SUBJECT: TECHNICAL SPECIFICATION CHANGES TO SUPPORT CYCLE 3 OPERATION
(TAC NO. 66921)

RE: SUSQUEHANNA STEAM ELECTRIC STATION, UNIT 2

AMENDMENT TO FACILITY OPERATING LICENSE

Amendment No. 45
License No. NPF-22

MAXIMUM AVERAGE PLANAR LINEAR HEAT GENERATION RATE (MAPLHGR) VERSUS AVERAGE PLANAR EXPOSURE
GE FUEL TYPES 8CR233 (2.33% ENRICHED)
FIGURE 3.2.1-2

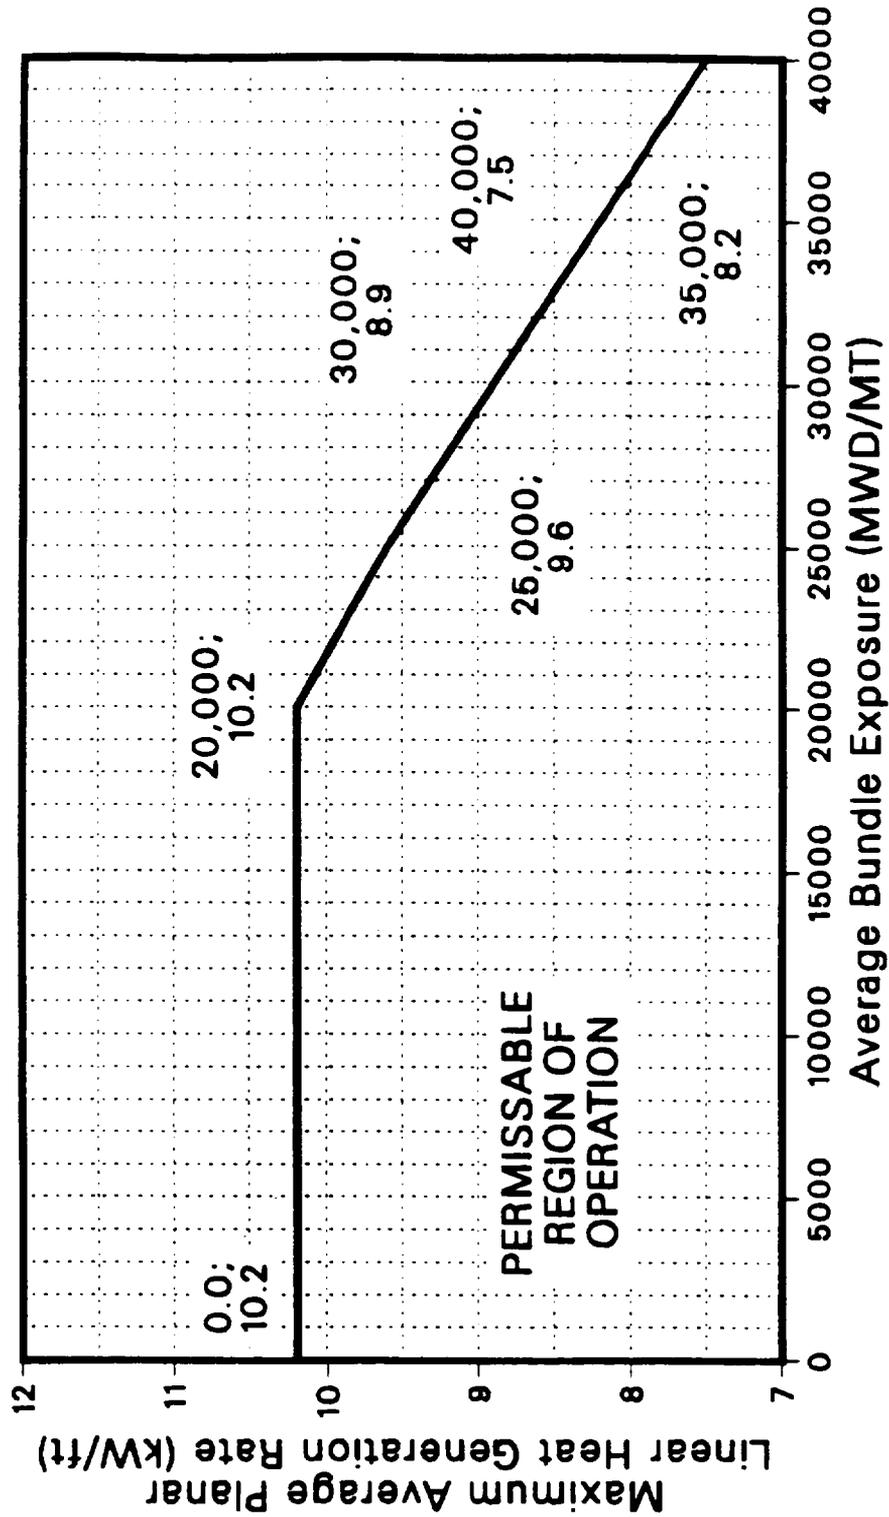
The GE loss of coolant accident (LOCA) analysis and maximum average planar linear heat generation rate (MAPLHGR) limits for the GE 8X8 fuel remain applicable for Cycle 3 although an additional exposure point at 40,675 MWD/MTU is added to the GE Type III MAPLHGR limit curve. The staff has previously approved this new curve for S1C3 operation and finds it acceptable for GE Type III fuel in S2C3 as well. The licensee has also presented MAPLHGR limits for the ANF 9X9 fuel based on the analysis results provided in XN-NF-86-65. The LOCA analyses have covered an acceptable range of conditions, have been performed with approved methodology, and the results meet the limits specified in 10 CFR 50.46. Therefore, the staff finds the proposed MAPLHGR limits for S2C3 acceptable.

The allowed exposure for GE 2.33 w/o enriched fuel has been increased to 40,675 MWD/MTU. In addition, editorial changes to correct misarranged wording and the vendor reference are made.

The change to the GE limit is based on an approved GE LOCA analysis and is acceptable as discussed in Section 4.3 of this SER. The editorial changes include the replacement of references to "Exxon" with "ANF" to reflect the corporate name change. These editorial changes are administrative only with no safety significance and are, therefore, acceptable.

FIGURE 3.2.2-1

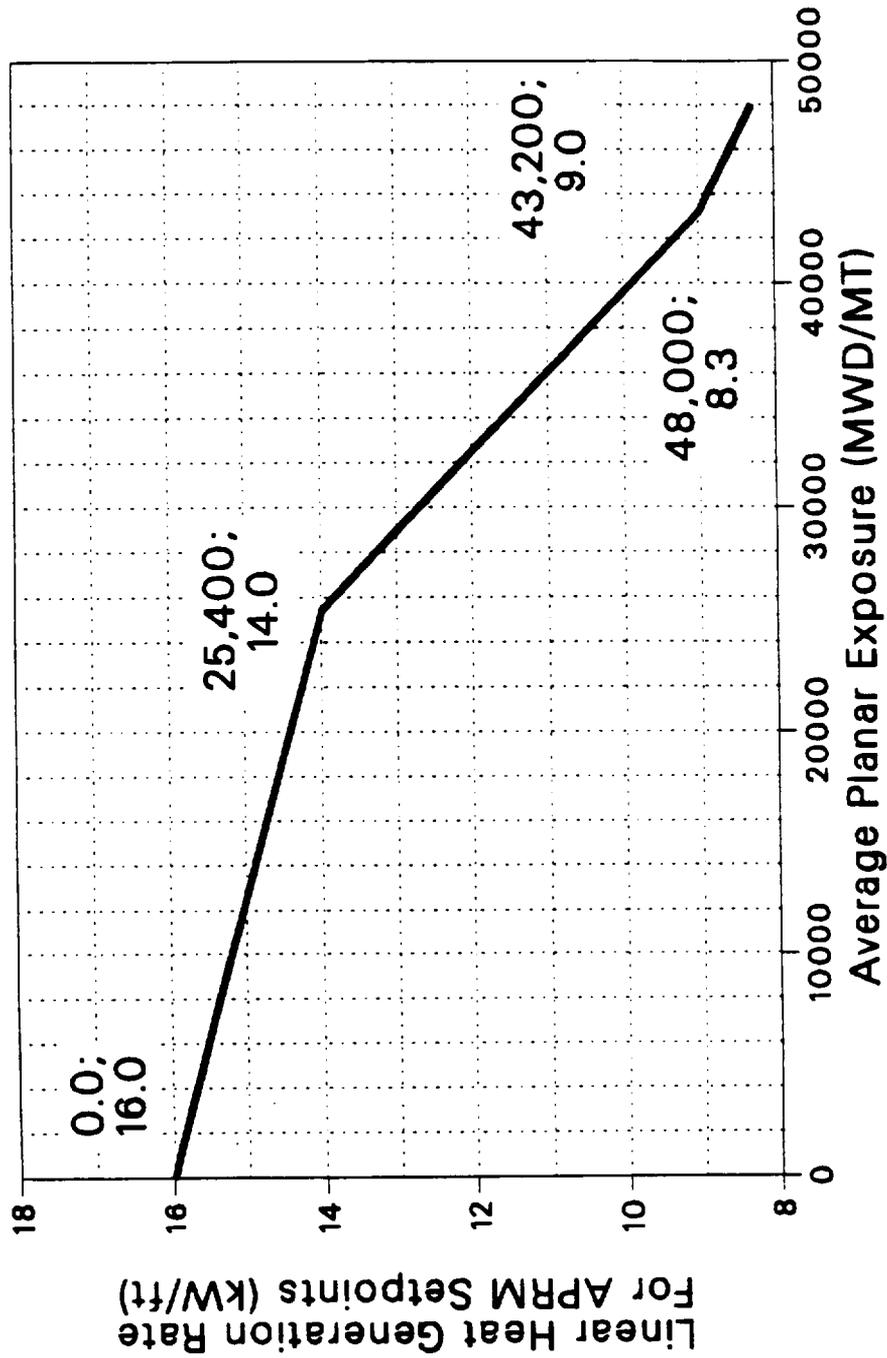
For ANF fuel the T factor used to adjust the APRM setpoints is based on the FLPD calculated by dividing the actual LHGR by the LHGR obtained from Figure 3.2.2-1. The LHGR versus exposure curve in Figure 3.2.2-1 is based on ANF's Protection Against Fuel Failure (PAFF) line shown in Figure 3.4 of XN-NF-85-67(A), Revision 1. Figure 3.2.2-1 corresponds to the ratio of PAFF/1.2 under which cladding and fuel integrity is protected during A00's.

FLOW DEPENDENT MCPR OPERATING LIMIT
FIGURE 3.2.3-1

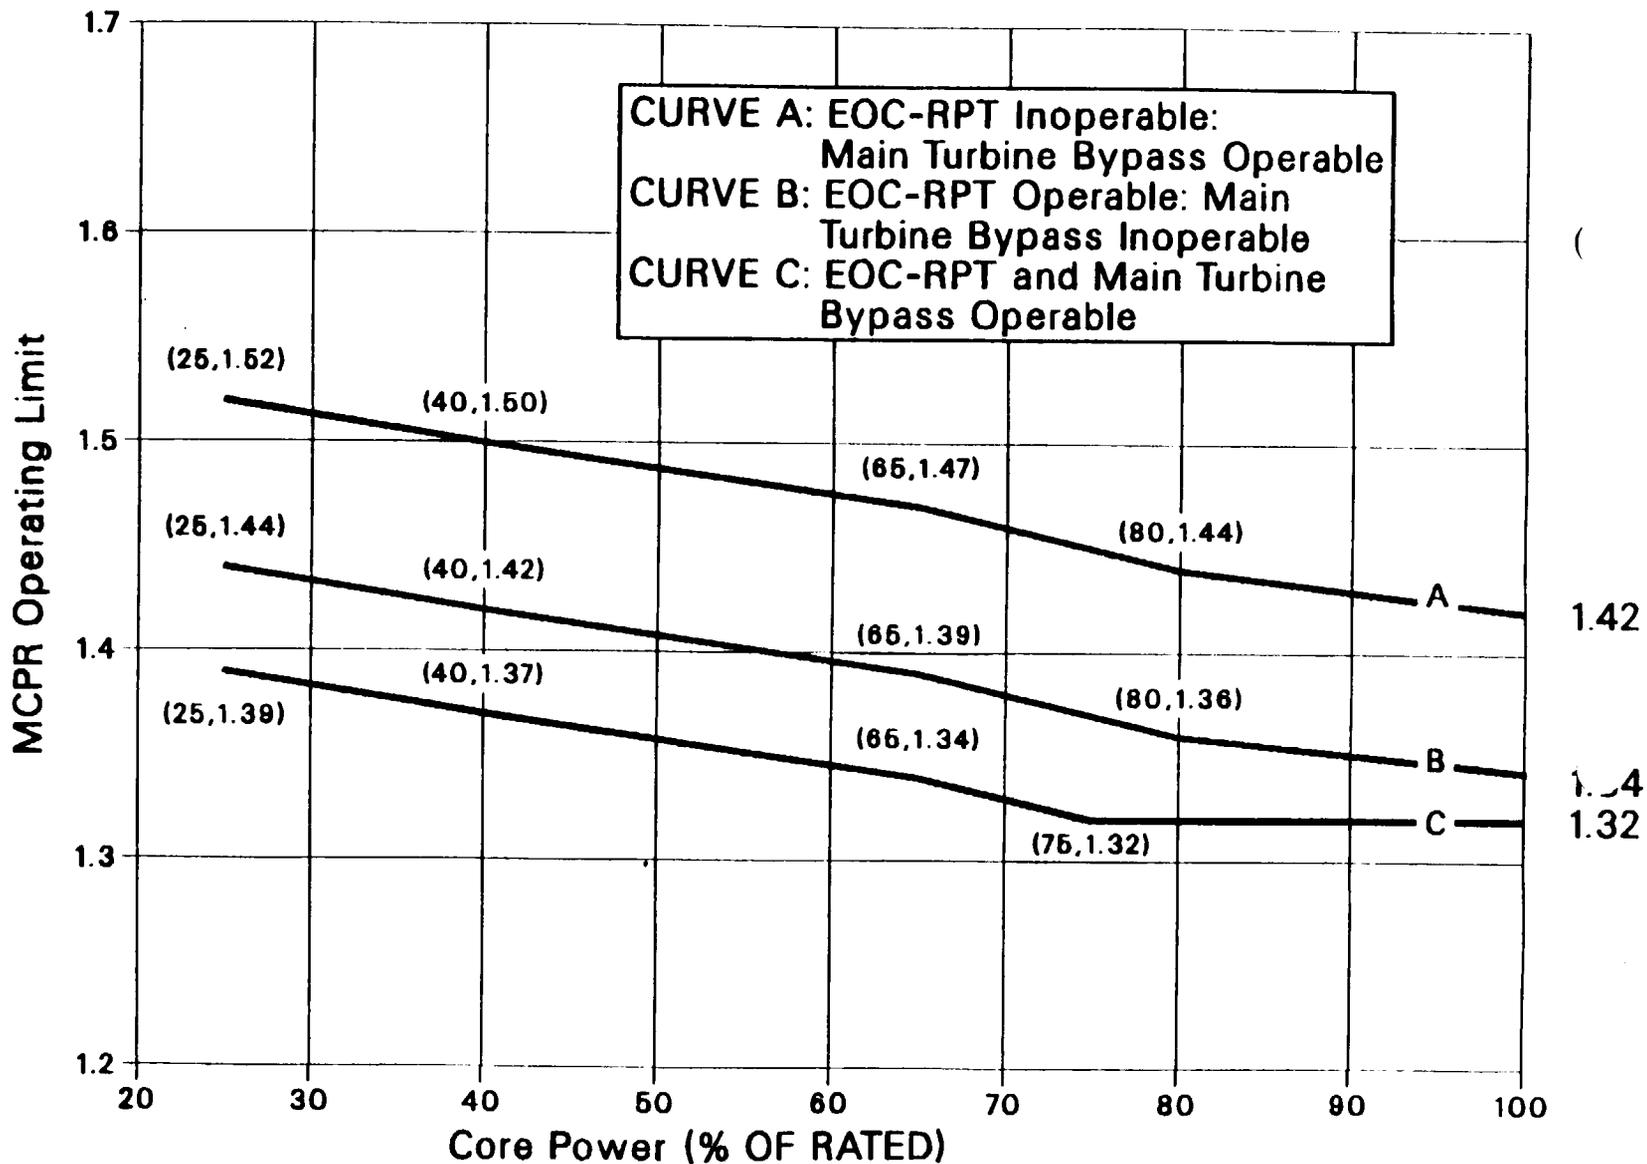
At reduced flow conditions, the recirculation flow control failure is limiting and MCPR operating limits for manual flow control reduce flow operation for Cycle 3 based on the analysis of this event are provided as a Technical Specification figure of MCPR versus core flow. These calculations were performed with approved methodology and the resulting Technical Specification limiting curves are acceptable.

Operating limit MCPRs have been revised to reflect the results of the cycle specific transient analyses.

The methodology used to evaluate the limiting transients and accidents is consistent with previously approved methods and meets all the appropriate NRC criteria. Therefore, the revised MCPRs are acceptable for Cycle 3 as discussed in Section 5.0 of this SER.

LINEAR HEAT GENERATION RATE (LHGR) LIMIT
VERSUS AVERAGE PLANAR EXPOSURE
ANF 9X9 FUEL
FIGURE 3.2.4.2-1

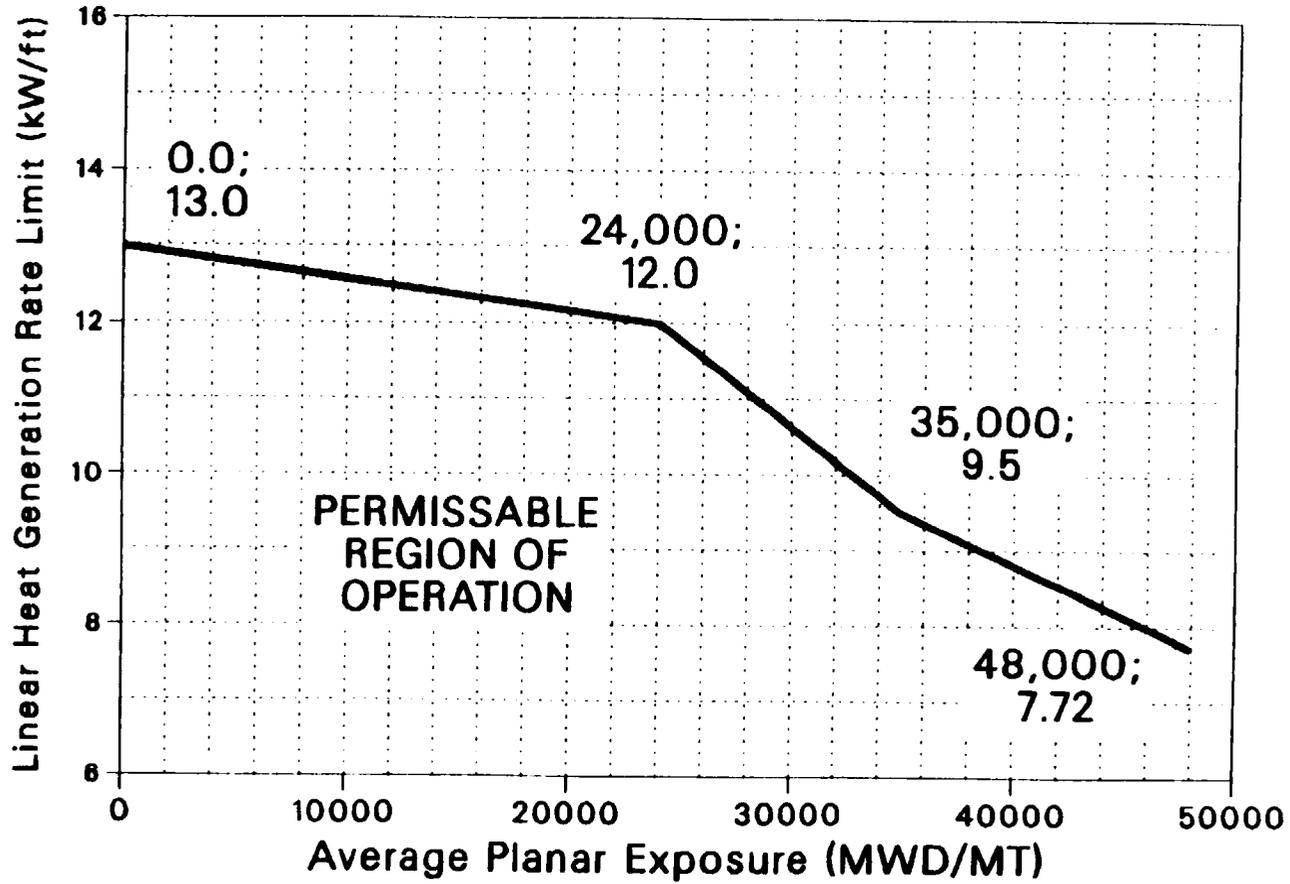
A figure of LHGR limit versus Planar Exposure (MWD/MT) for the ANF 9X9 fuel type is incorporated into the Susquehanna 2 Technical Specifications. This Figure was approved in the staff's safety evaluation dated July 23, 1986 to reflect the design values which have been previously reviewed and approved for the ANF 9X9 fuel in connection with the Staff's review of XN-NF-85-67, Revision 1. Based on the results of the generic review the staff finds the LHGR limits for the 9X9 fuel acceptable.
